**Operator: BCEI**

**Location Name: Antelope 14-21 Pad**

**Loc ID: 441376**

**Inspection: 696306435**

**Exhibit D**

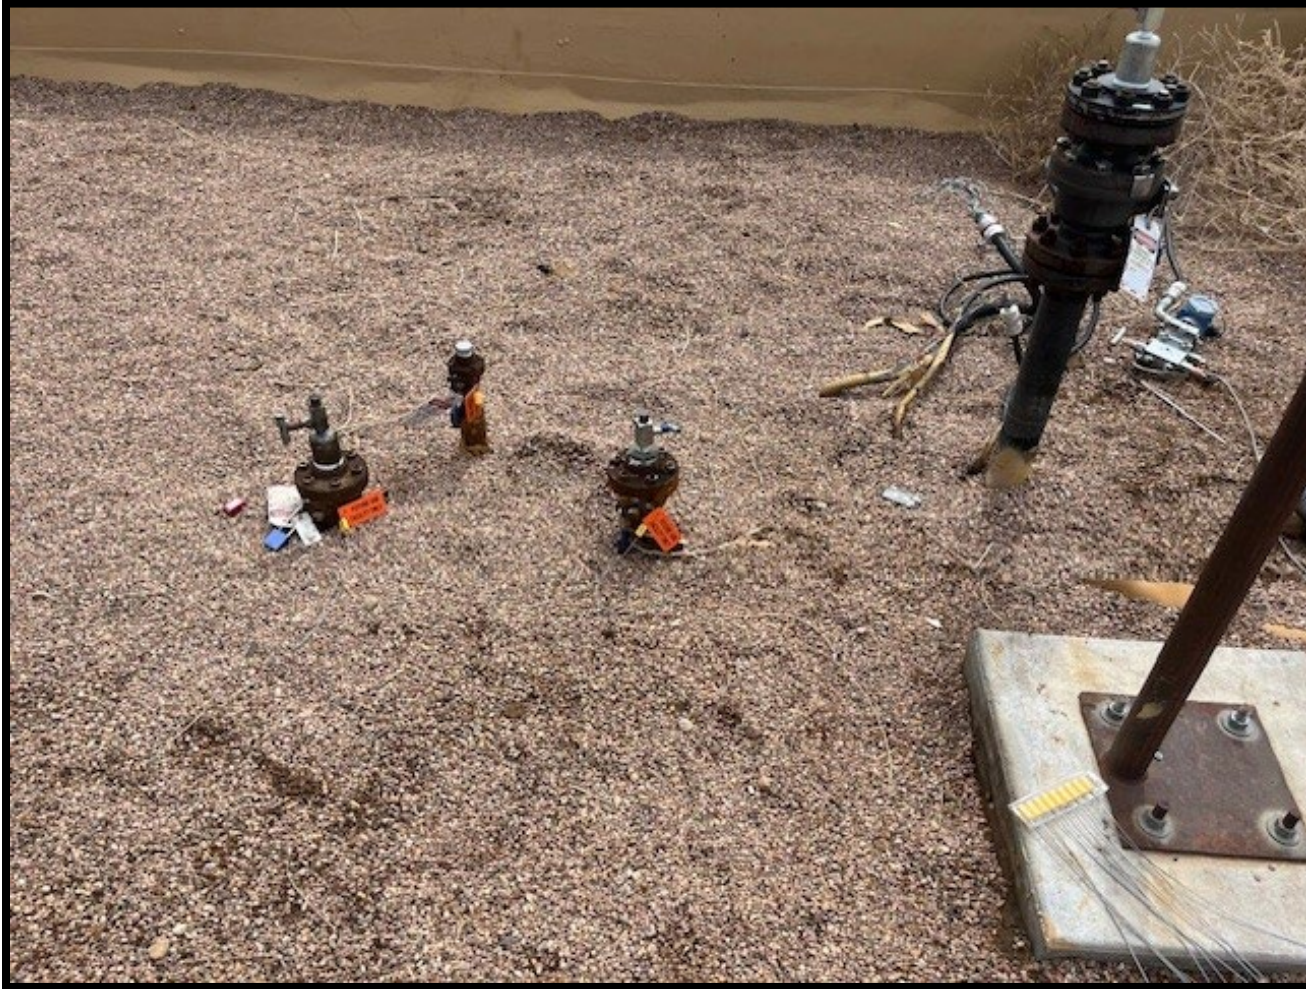
**CA:** Unmarked Risers at various Wellheads and Separators. Upon removing a flowline or crude oil transfer line from use with the intent to abandon, an operator must immediately apply OOSLAT to the risers. OOSLAT must stay in place at all times during the process of abandoning the flowline or crude oil transfer line until the operator removes the riser. Comply with Rule 1105.b.

**CA Resolution:** Operator has reported that various risers have now been appropriately marked to comply with Rule 1105.b.
